PLANNING AND DEVELOPMENT SERVICES STAFF REPORT

For Planning Commission Meeting of October 4, 2011

**SUBJECT: University Bank PUD Supplemental Regulations and PUD Site Plan
(2015 Washtenaw Avenue)
File Nos. Z09-028 & SP09-029**

CLIENT: UNIVERSITY BANK
DIMENSION & PAVING PLAN
2015 WASHTENAW AVENUE
CITY OF ANN ARBOR, WASHTENAW COUNTY, MI

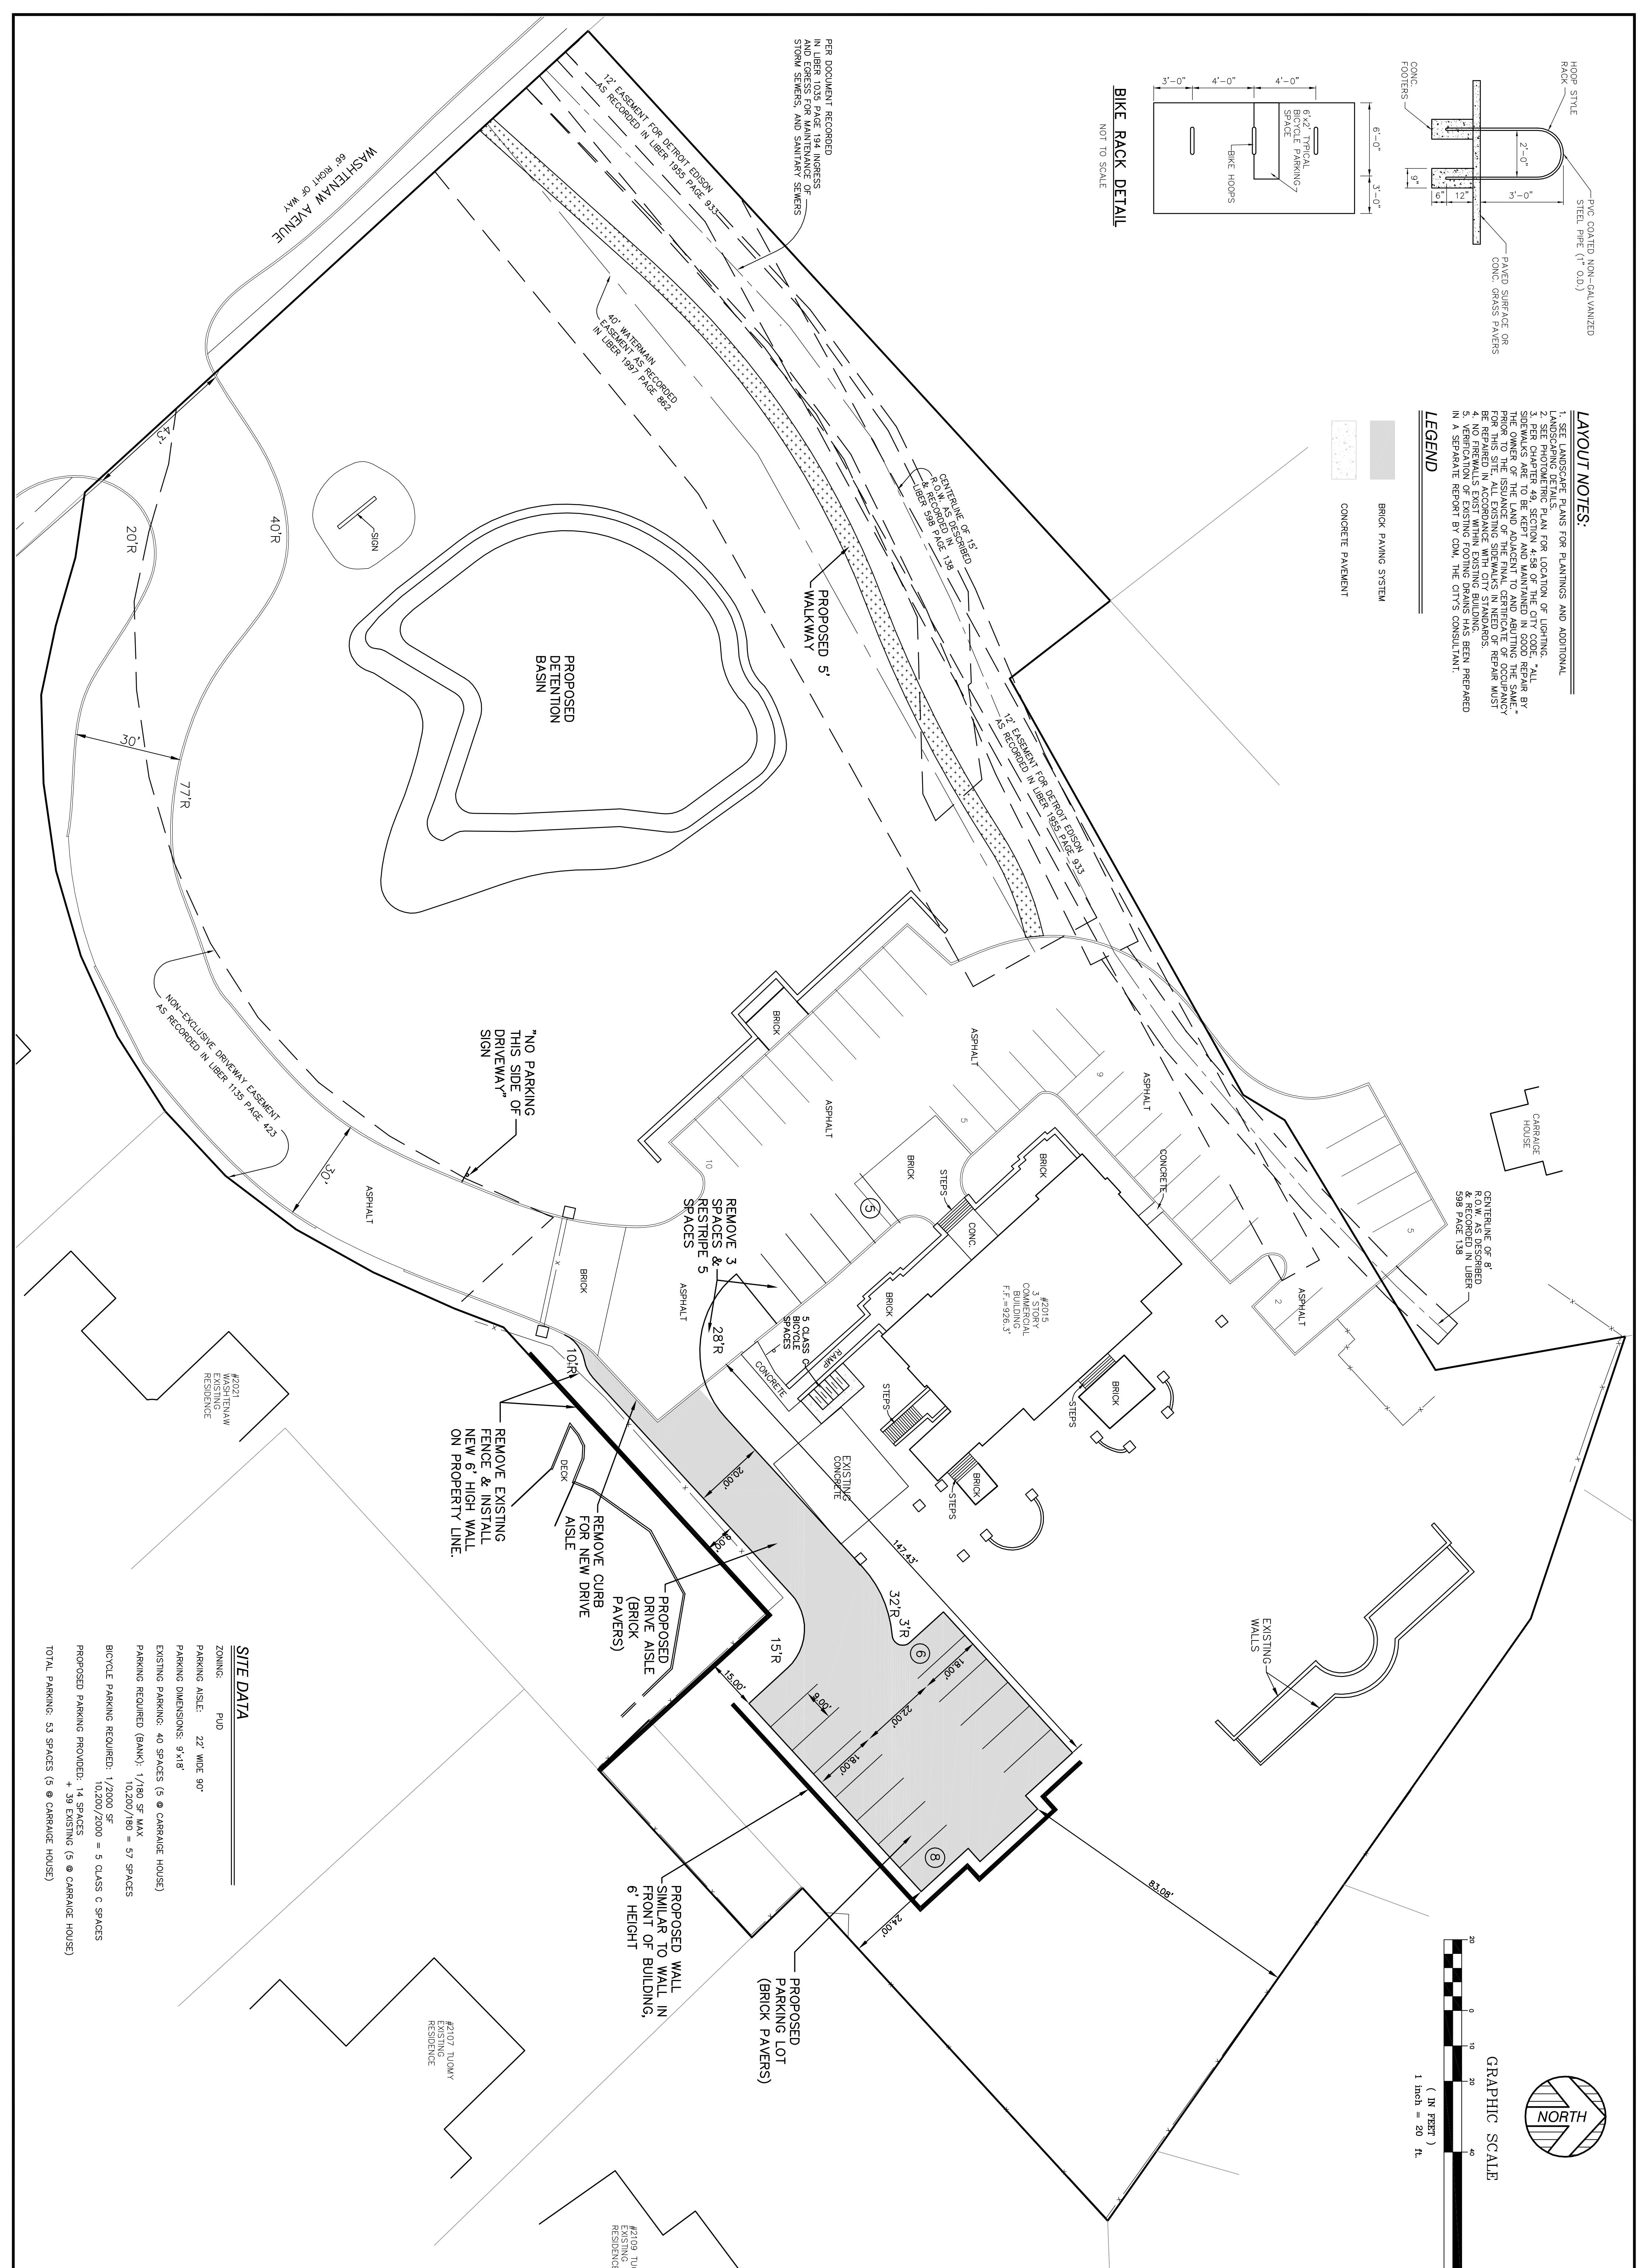
The revised parking lot layout has been shifted an additional nine feet toward the building, for a new setback of 24 feet from the eastern property line. A continuous six-foot tall wall is proposed to be constructed along the eastern and southeastern property lines, screening the parking lot from 2021 Washtenaw Avenue and 2107-2109 Tuomy.

Three parking spaces fronting the bank building are proposed to be removed to meet Fire Department turning radius requirements for a new parking total of 50 spaces. A "No Parking Sign" is proposed along the north side of the entrance drive across from 2021 Washtenaw Avenue.

Planning – Staff supports the proposed parking lot layout with increased side setbacks and screening walls from the adjacent neighbors. The revised location of the new parking lot has less impact on the woodland trees from the previous proposal and over-mitigates for the removal of these landmark and woodland trees. Based on commentary at earlier meetings, the alternative for constructing the new parking lot in the large lawn area in front of the building was considered to be undesirable. At the September 1, 2011, meeting between the bank and neighbors, both parties indicated they were satisfied with the proposed new parking lot being located further away from the woodland and residential properties and with the proposed increase in landscaping and screening.

Landscape And Tree Protection Plan for:

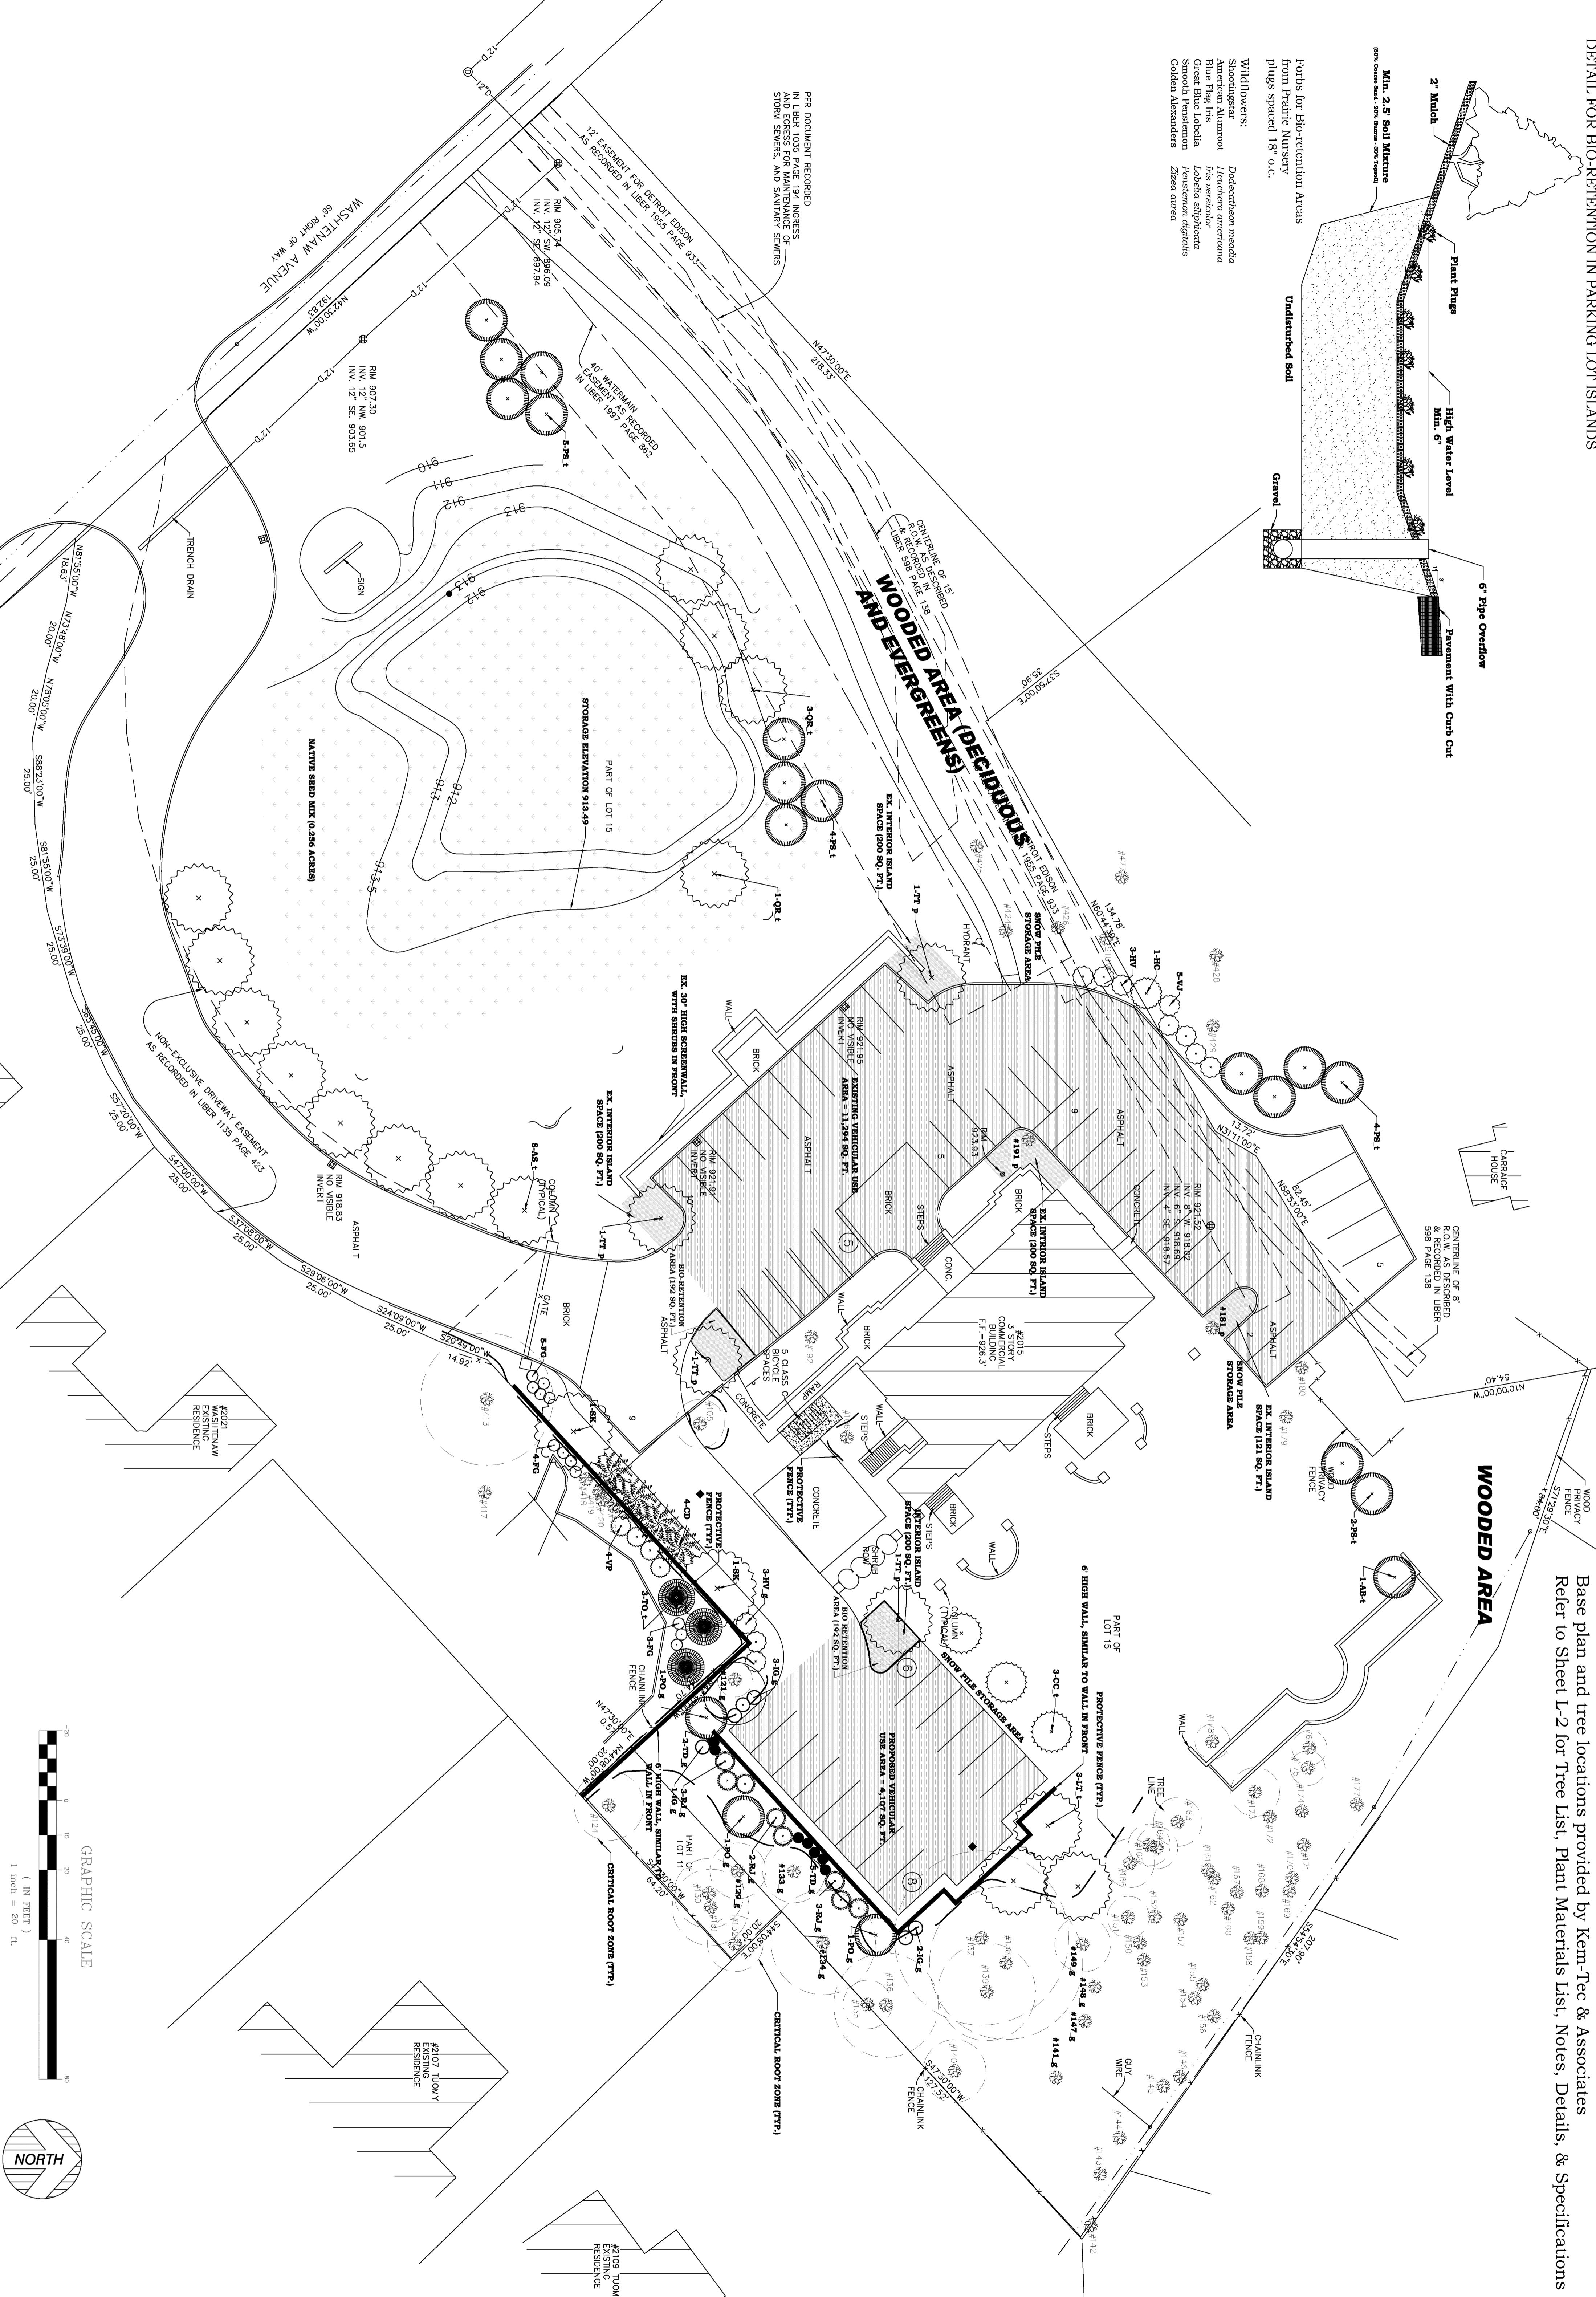
The petitioner proposes removing two landmark and 19 woodland trees totaling 186 caliper inches for construction of the screening wall, 14-space parking lot and connection drive. By shifting the parking lot an additional nine feet away from the woodland, a reduction of 46 caliper inches is proposed when compared with the previous mitigation plan. The petitioner proposes to exceed the required tree mitigation by planting for 223 caliper inches. These mitigation trees are to be planted throughout the site.

The petitioner proposes to mitigate for all trees removed due to the parking lot construction, not just the two landmark and 19 woodland trees. This landscape mitigation exceeds the minimum required. Along with this increase in landscaping, the petitioner agreed to increase the required 15-foot conflicting land use buffer to 24-feet and increase the conflicting land use wall from 3 feet to 6 feet in height and extend the eastern screening wall approximately 28 additional feet to provide additional screening for the neighbors. These landscaping mitigation, setback, height and length increases are beyond that required by code and have been incorporated into the PUD supplemental regulations.
